# CITY OF SOMERVILLE

**Site: 10 Prospect Street**

**Case #:** PB 2019-04

## STAFF REPORT

#### Transportation Access

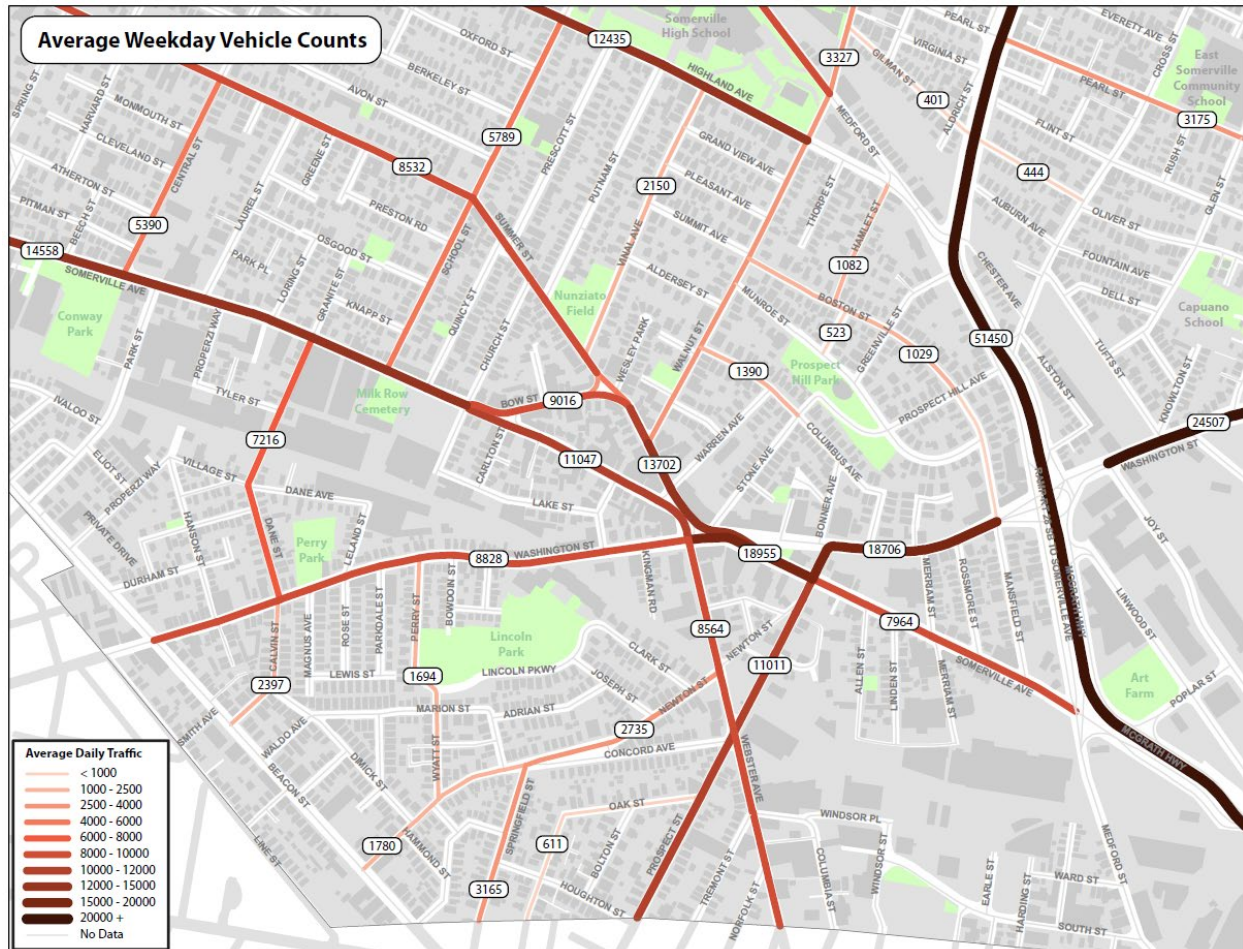
Development of the D2 site will close three (3) curb cuts along Somerville Avenue and two (2) curb cuts along Prospect Street, replacing them with one (1) new curb cut for Bennet Court (intersecting with Prospect Street) and one (1) curb cut for Milk Alley (intersecting with Somerville Avenue). Each curb cut will be wide enough to accommodate two-way motor vehicle traffic. Charlestown place is intended to intersect with Charlestown Street at Allen Street near the rear of the D2 site, but will require DSPR as it was not included at this time as part of the proposal due to ongoing coordination between the Applicant, the City of Somerville, and EverSource to address utility pole locations.

The demand for parking by employees, residents, customers, and visitors for all three (3) buildings proposed for the combined D2 site will be accommodated by the two hundred and sixty-nine (269) space commercial vehicular parking facility proposed for D2.2 and D2.3. Loading and service for D2.1 will occur through a three (3) bay loading dock accessible from Milk Alley. The loading dock accommodates two WB-40 (wheel base 40) tractor semi-trailer trucks to service commercial tenants on upper stories and one smaller bay for a single unit box truck to service ground floor uses. Waste pick-up will also occur through the loading dock. Primary access for the loading dock is proposed to enter the alley system to and from Somerville Avenue. Bennet Court is proposed to accommodate access to and from Prospect Street, but deliveries are intended to be coordinated by the owner or future property management firm to occur at off-peak hours. Further information about vehicular circulation can be found in case #PB2019-03 which addresses the proposed thoroughfares.

To every extent practicable, the City intends to direct motor vehicle traffic to and from the D2 site onto Somerville Avenue east of the Prospect Street intersection due to the lower average weekday vehicle counts recorded as compared Washington Street, Prospect Street, or Somerville Avenue through the core of Union Square.

### Shadow Study

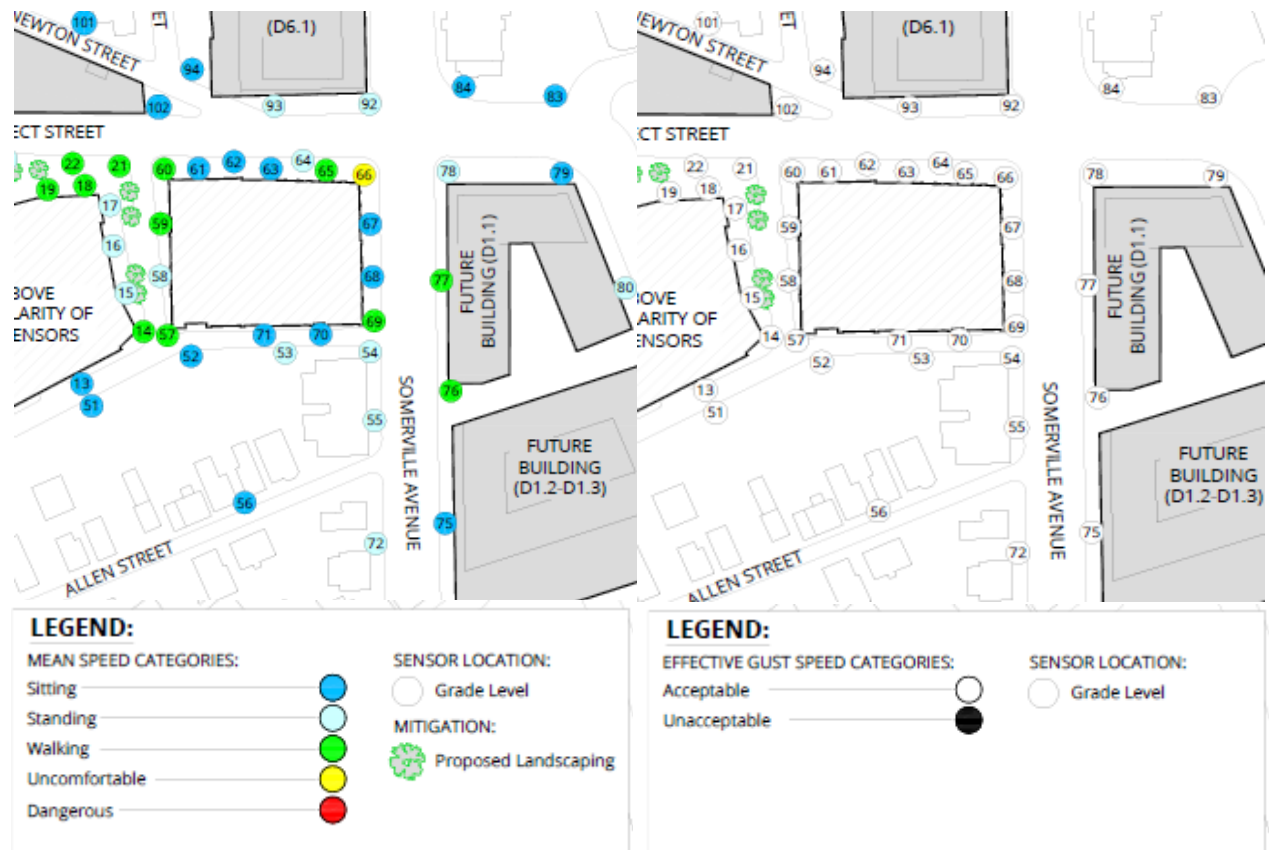
The Applicant submitted a shadow study prepared by Ground which illustrates estimated shadows at the spring and fall equinox, summer and winter solstice, and the cumulative new shadows. Generally speaking, the D2.1 building will shadow the abutting Prospect Street sidewalk during only the first half of the day and all or most of the Somerville Avenue abutting sidewalk for the entire day. During favorable weather, such as around the summer solstice (June 21) and fall equinox (September 21), rear gardens of Allen Street properties will have sunlight until about 4pm in the summer and until about 2pm in the fall. The civic space at 30 Allen Street is estimated to be cast in new shadows beginning at 6pm in the summer and 5pm in the fall. The City is investigating any necessary changes to landscaping plans for the Somerville Avenue streetscape and Allen Street civic space accordingly.
